**Title:**  
**TAILPIPE DURABILITY**
**Models:**  
**'95-'97 RAV4**
**EG006-98**
**ENGINE**

**Introduction** To improve muffler and tailpipe durability, the Tail Pipe Assembly has been modified. For 4WD models, a dynamic damper has also been added on the Center Exhaust Pipe Assembly.

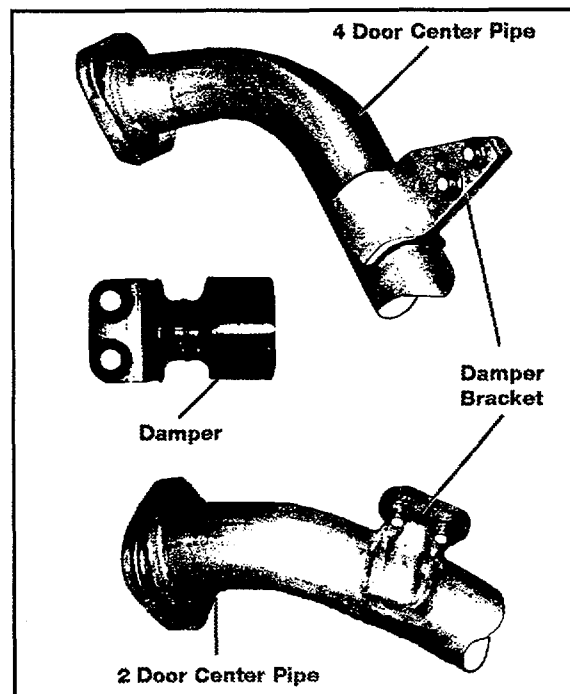
- A. 2WD Models:
- Replace Tail Pipe Assembly.
- B. 4WD Models:
1. Replace Tail Pipe Assembly.
  2. Install Exhaust Pipe Damper No.2 to bracket indicated in illustration.
